**North Carolina Office of the State Fire Marshal
Engineering and Building Codes Division in the Department of Insurance**

RE: Appeal of the December 10,)
2025, Decision of the Harnett)
County Central Permitting)
Office to cite a code violation of)
2018 North Carolina Residential)
Code (NCRC), Section R305.1)
and require a uniform 7-foot)
ceiling height across the entire) OSFM DECISION
width of a newly-renovated)
hallway connecting a newly-)
renovated bedroom and)
common area in the attic of a)
connected garage to the)
existing second floor habitable)
space of a house located at 155)
Grayson Place, Sanford, NC.)

This appeal concerns the interpretation and application of minimum ceiling height requirements for an existing hallway providing access from a Room Over Garage (ROG) to a habitable attic space at 155 Grayson Place, Sanford, North Carolina (Permit No. BRES2508-0038).

Figure B-4 – Sloped Ceiling Outside Primary Walking Path (Point-Cloud Cross View)

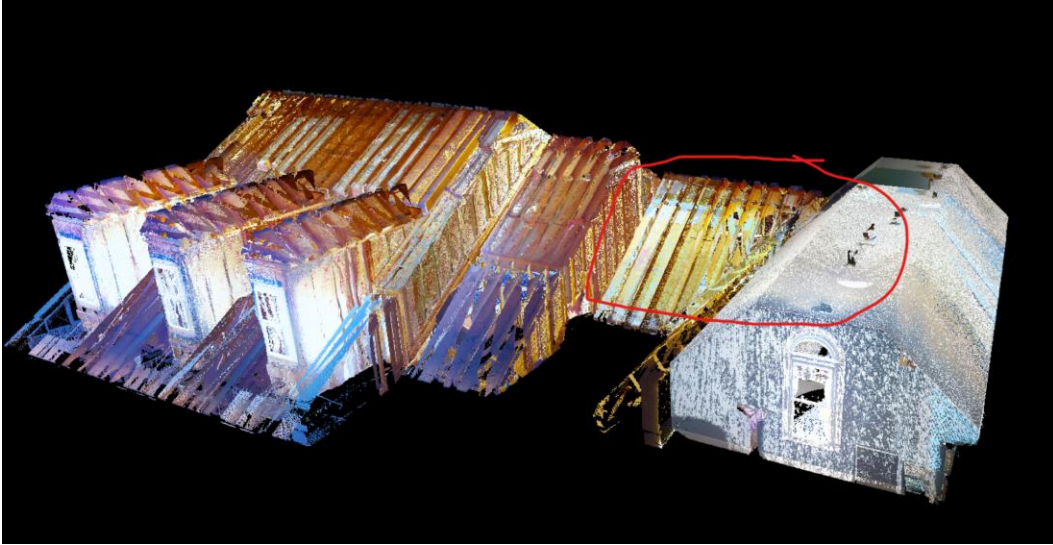
4. 2018 NCRC, Section R305.1 requires hallways to have a ceiling height of not less than 7'-0" from the finished floor and no exceptions are provided in the code to allow for a reduction to a lesser ceiling height dimension to account for sloped ceilings or other obstructions in hallways. If Exception #1 to 2018 NCRC, Section R305.1 was applicable to hallways, the newly-renovated hallway center portion of the ceiling at 7'-0-1/2" from finished floor equates to less than the 50% floor area requirement of Exception #1.

5. In the conversion of the non-habitable attic space to a habitable attic space, the appellants request for a modification under 2018 NCEBC, Section 104.10 to allow a reduced ceiling height in the hallway does not meet the intent and purpose of the current code and furthermore increases the risk to life and fire safety because the hallway egress does not meet the prescriptive requirements of the current code.

Based on the above findings and conclusions of the information considered in this appeal, the appellee's decision to require a uniform 7-foot ceiling height across the entire width of a newly-renovated hallway connecting a newly-renovated bedroom and common area in the attic of a connected garage to the existing second floor habitable space of a house located at 155 Grayson Place, Sanford, NC is UPHELD.
